DEVELOPMENT REVIEW BOARD
SUPPLEMENTAL SUBMITTAL

PROJECT NO. 2018-001579
Application No. SI-2020-01477

This letter outlines the modifications that have been made to the Apartments at Pennsylvania St and Indian School Rd application for a major site plan amendment to the approved Winrock Town Center Site Development Plan (PR-2018-001579) to address the agency comments that were received.

Lofts @ Winrock Town Center

TITLE: **CONCEPTUAL UTILITY PLAN**

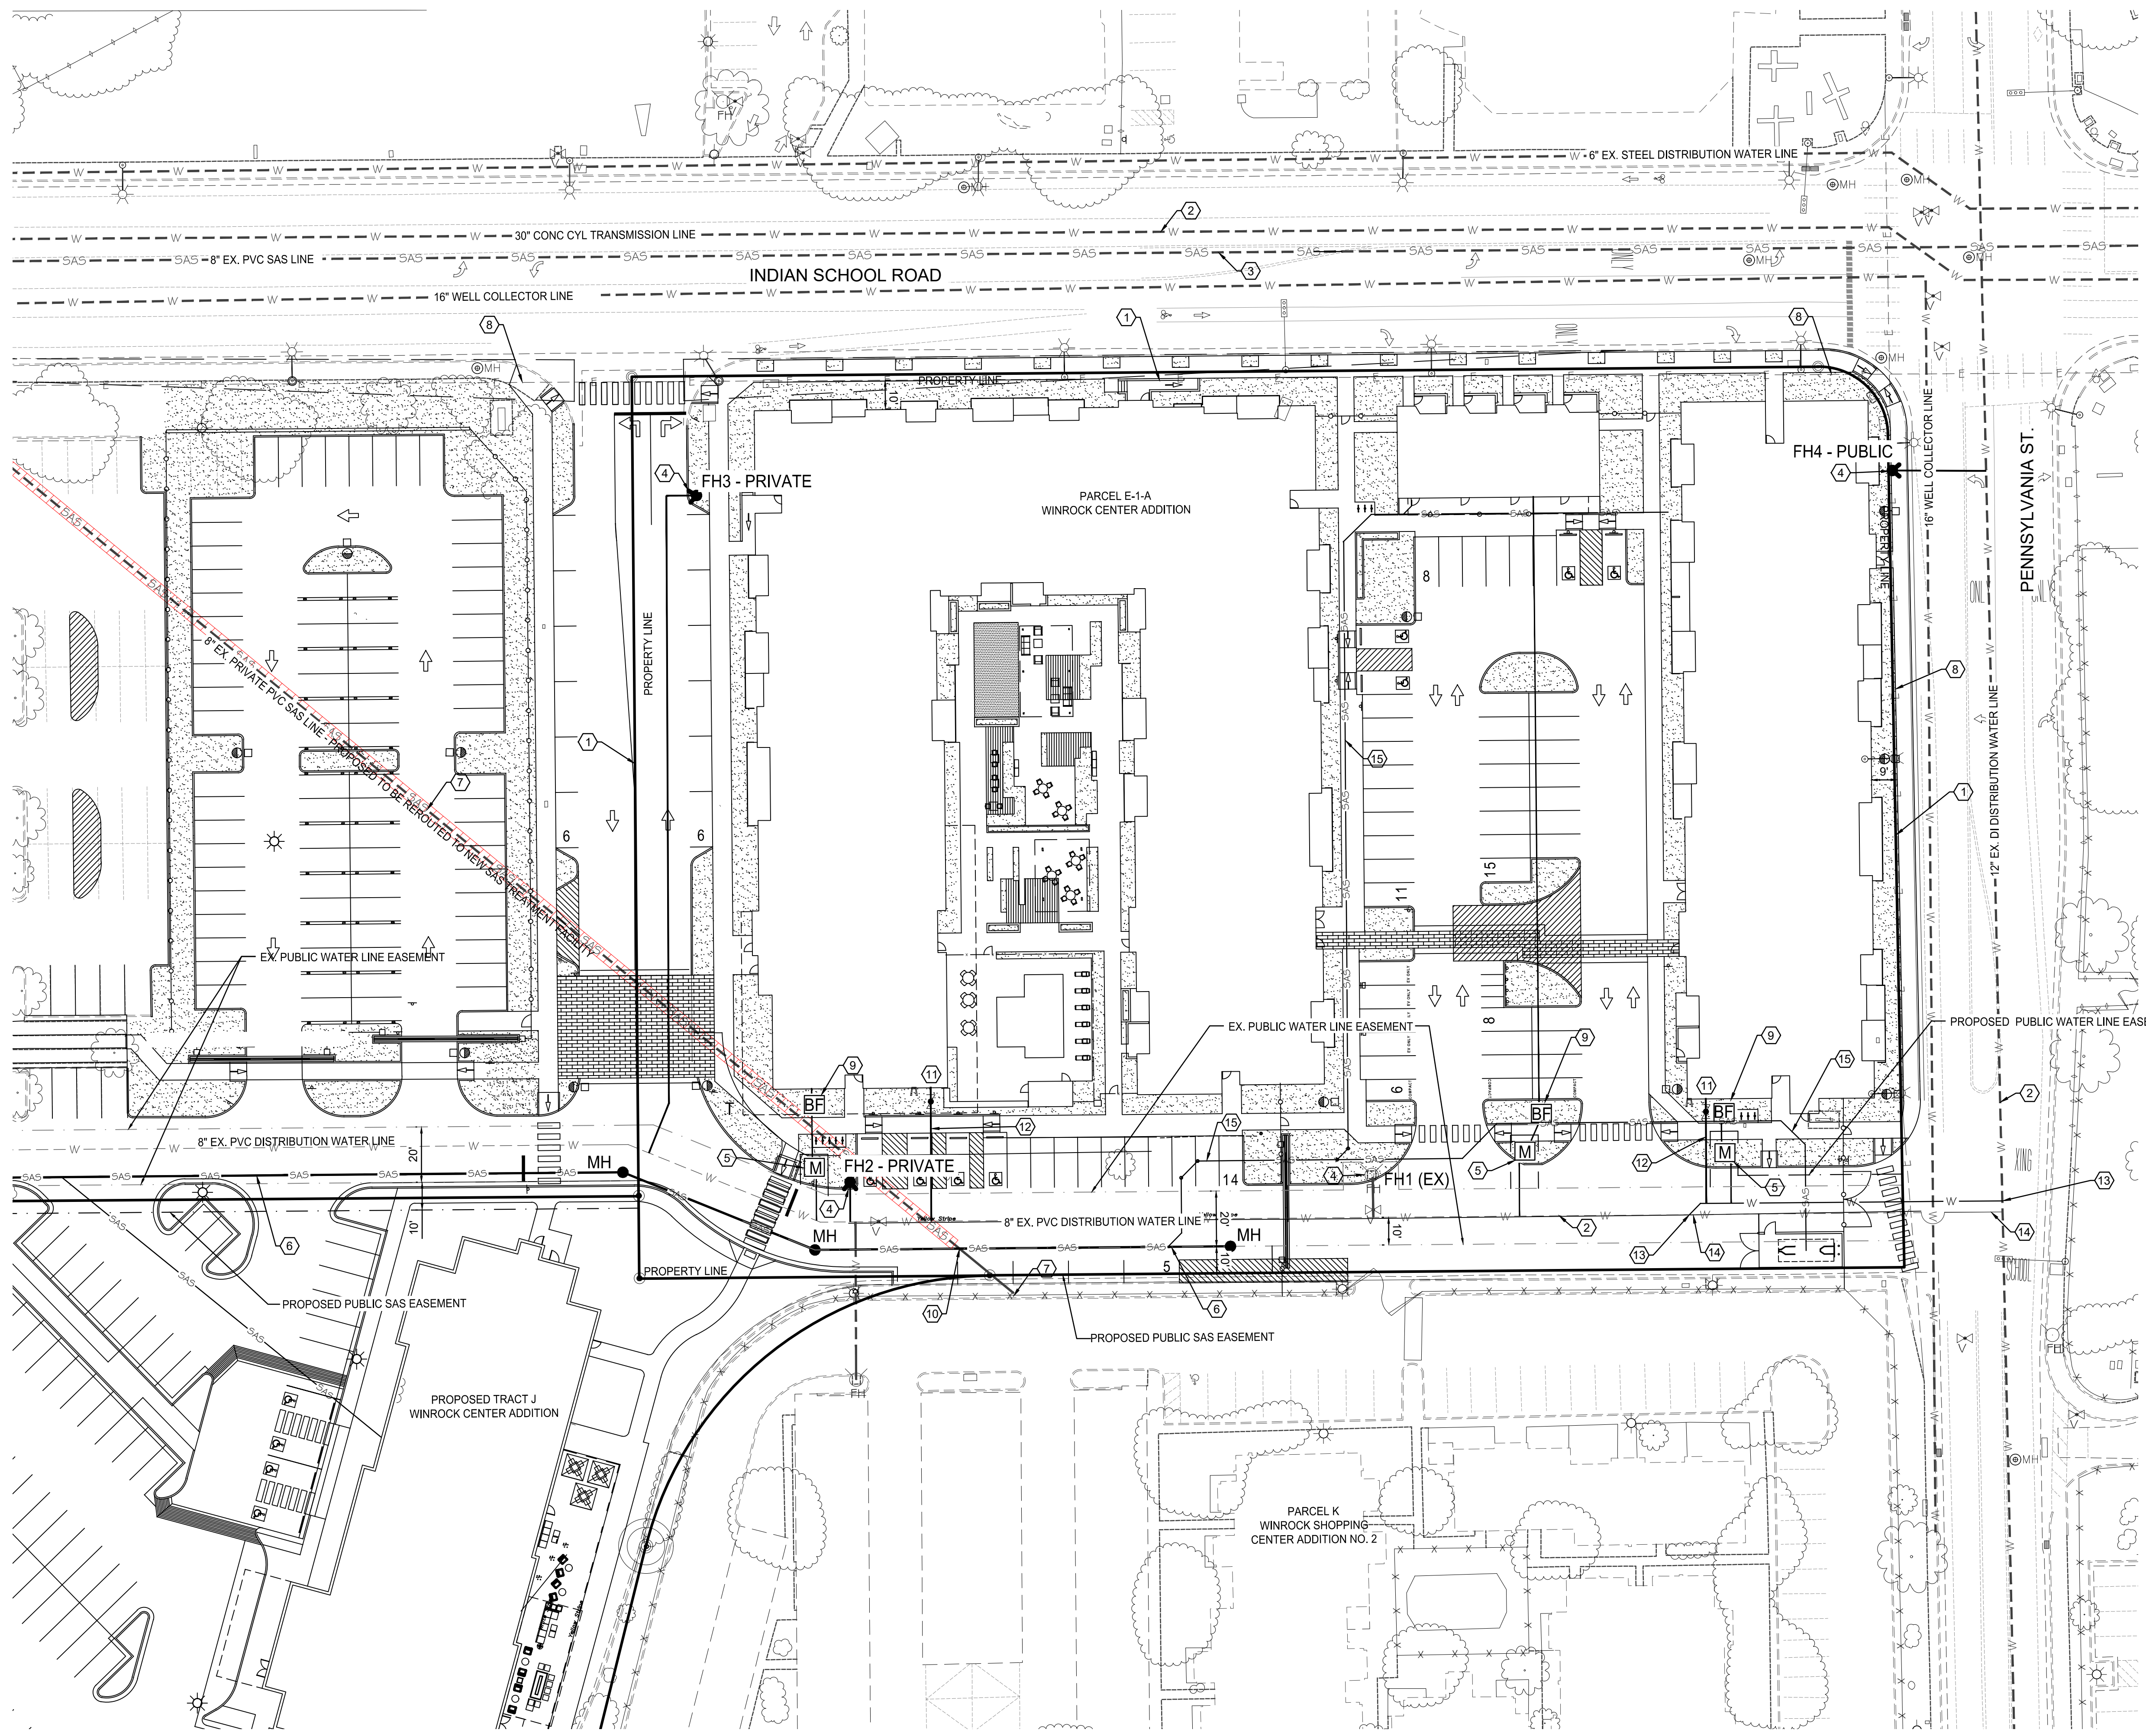
- b. Conceptual Utility Plan (stamped/signed 4/9/21)
 - i. Please review keyed notes and ensure they are appropriate as the Enlarged Utility Plan has some incorrect references and keyed notes.

Keyed notes updated.

TITLE: CONCEPTUAL ENLARGED UTILITY PLAN

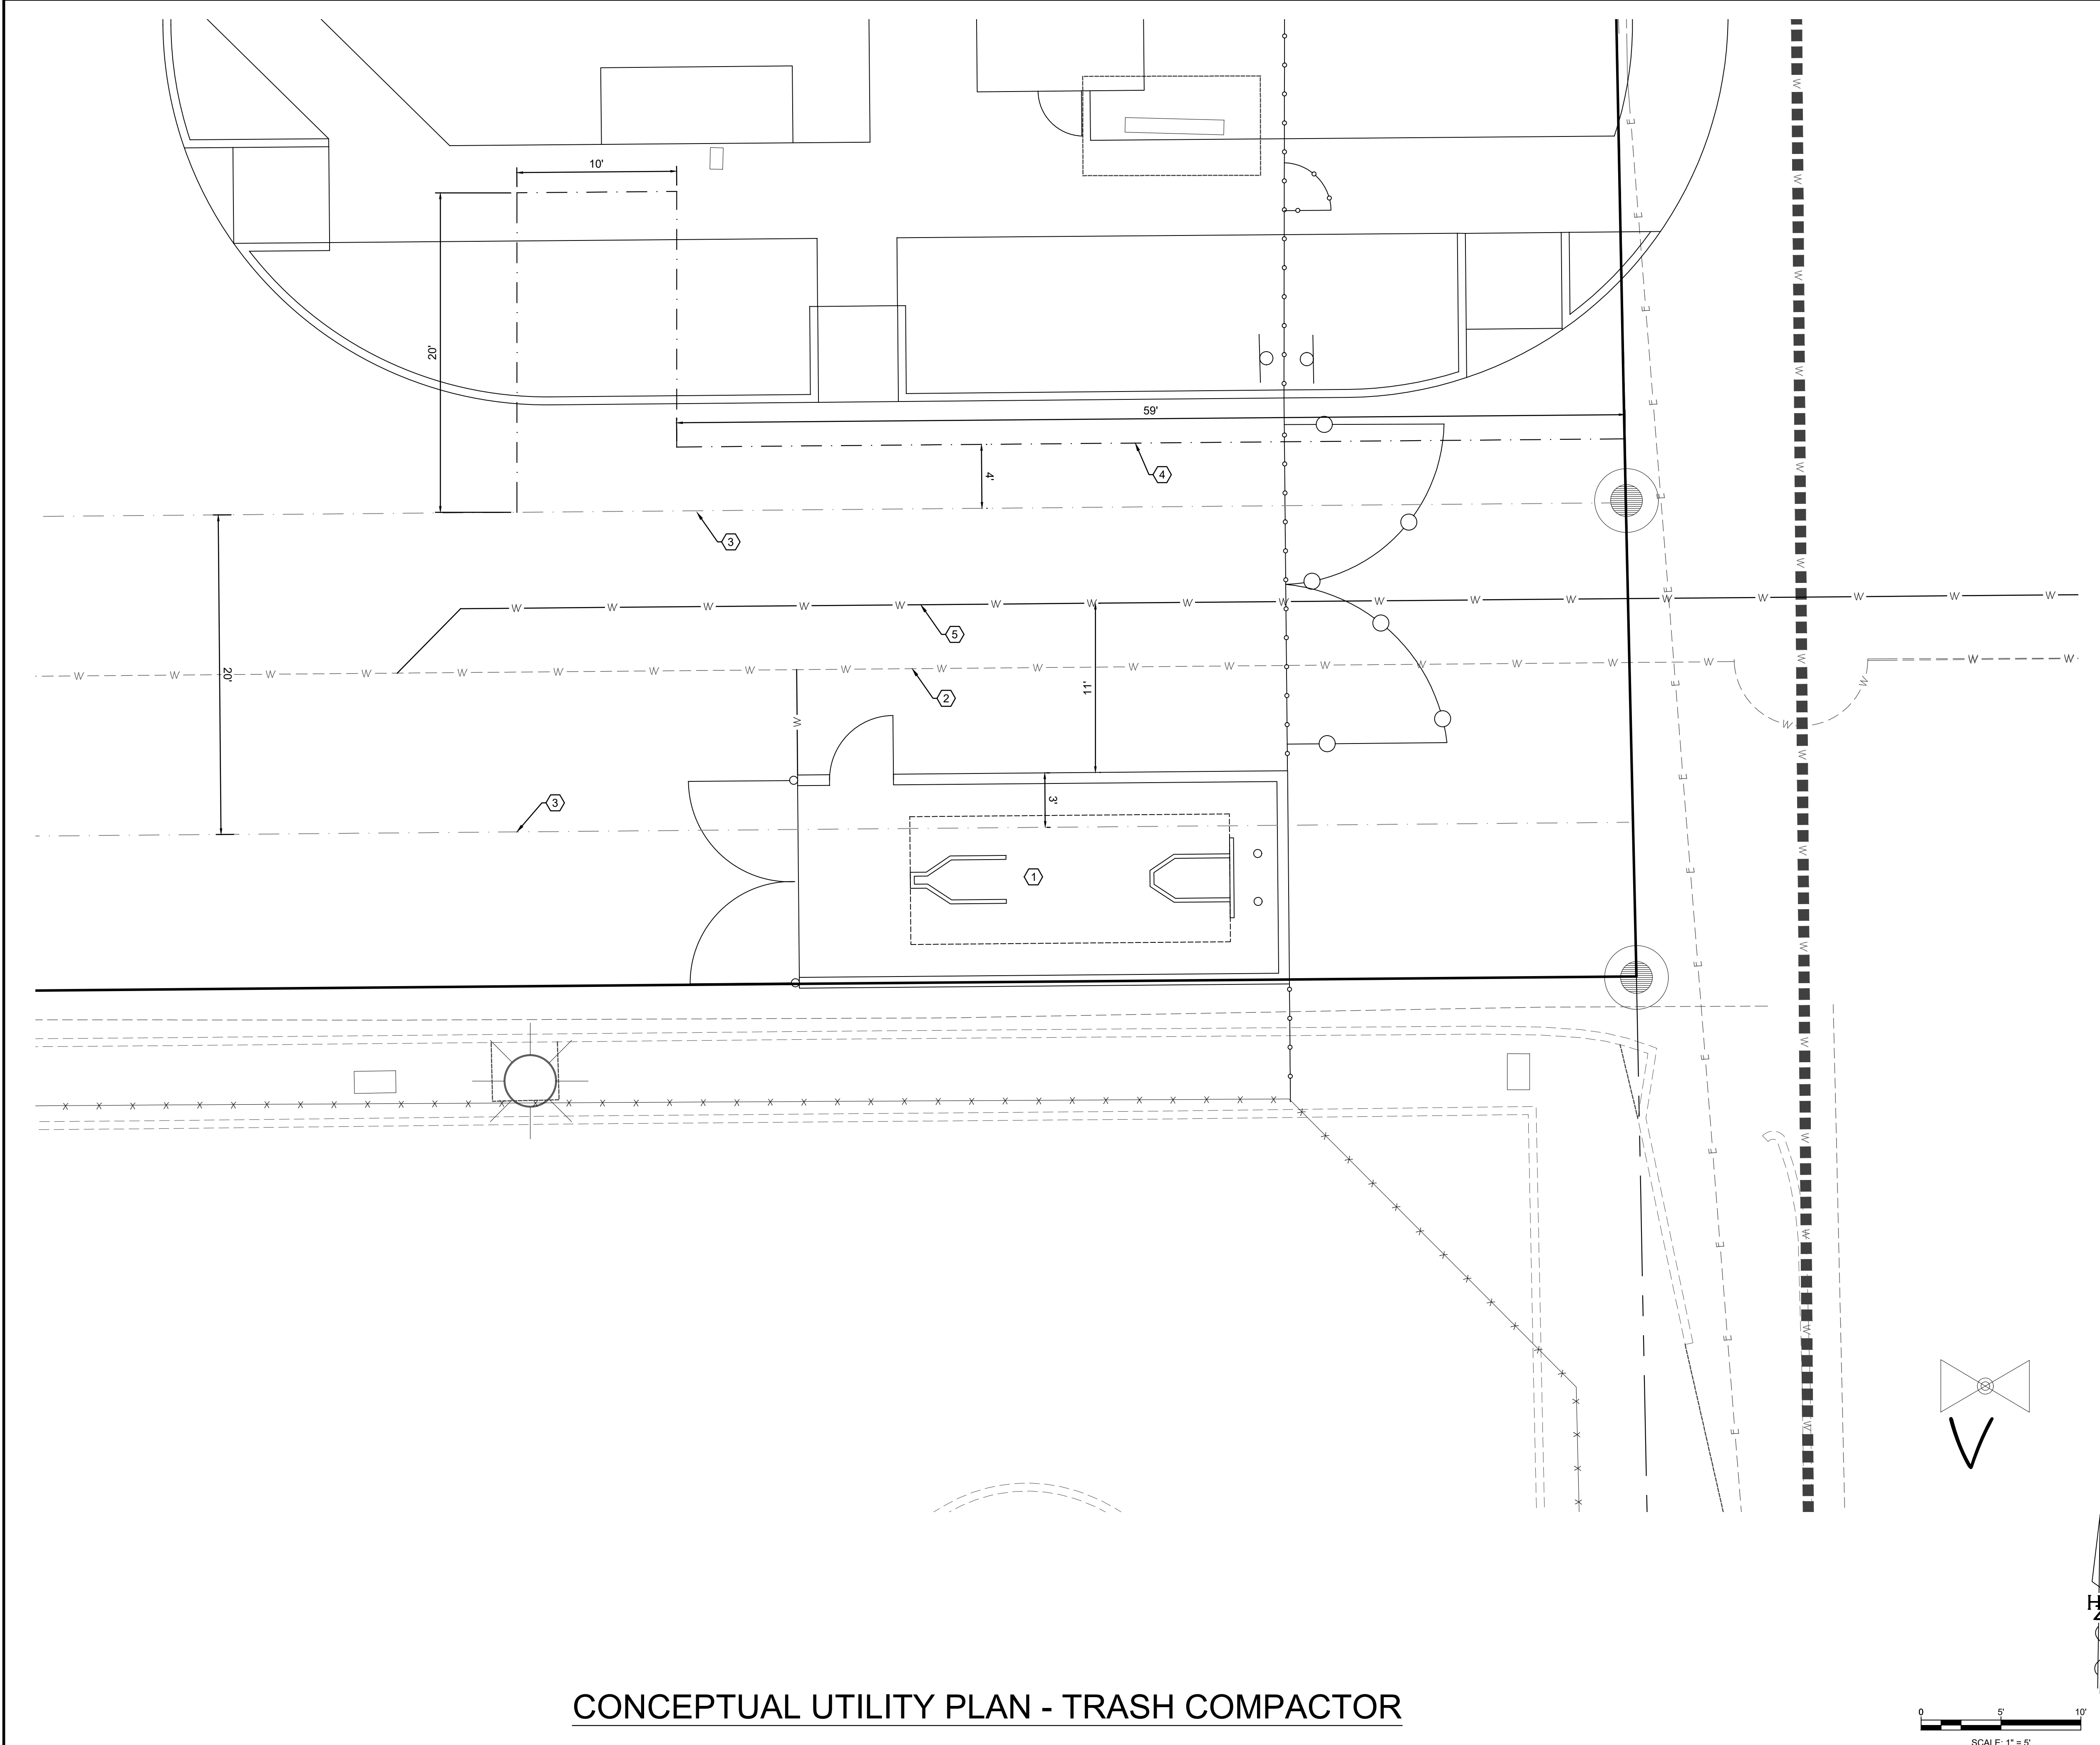
- ii. The proposed trash compactor (keyed note #41) cannot encroach into the public waterline. Please relocate either the trash compactor or the waterline.
- e. Conceptual Enlarged Utility Plan (stamped/signed 4/9/21)
 - i. Please indicate public sanitary sewer for Keyed Note #3.

- ii. Please add another keyed note #6 onsite to show the extents of the proposed public sanitary sewer.

- iii. Keyed Note #10 indicates connecting existing private sanitary sewer to new private sanitary sewer when in fact it is known to be a proposed public sanitary sewer.

- iv. Backflow prevention shall be on all water meters and fire suppression systems.

- v. Keyed note #11 indicates a new joint use private sanitary sewer line to new public sanitary sewer line. Shared service is not allowed as each property shall connect separately to the public sanitary sewer line(s).
 - 1. This keyed note #11 appears to point to the existing public waterline.

- 2. Keyed note #6 is a public sanitary sewer yard line but is pointing to the private sanitary sewer service from the trash compactor.

- vi. PREVIOUS COMMENT: All proposed fire hydrants onsite shall be labeled as private. Fire hydrants in public right-of-way shall be labeled as public. The response to comments concurred, however FH#3 and FH#2 are labeled as public fire hydrants. Please label as private. FH#6 is not labeled and shall be private. FH#8 is not labeled and shall be public.

- vii. Please label the onsite existing and proposed public water and sanitary sewer easements with leaders.

The existing Public sanitary sewer line is an 8-inch.

Keyed note added within Parcel E-1-A.

Keyed note 10 revised.

Note added to fire lines indicating backflow prevention on fire suppression lines shall be within the fire riser room.

Keyed note #11 revised and relabeled.

Added keyed note #15 and relabeled.

Approved amended Fire One Plan requires 4 fire hydrants. Fire hydrants updated on the utility plan.

Leaders added to the easement labels.
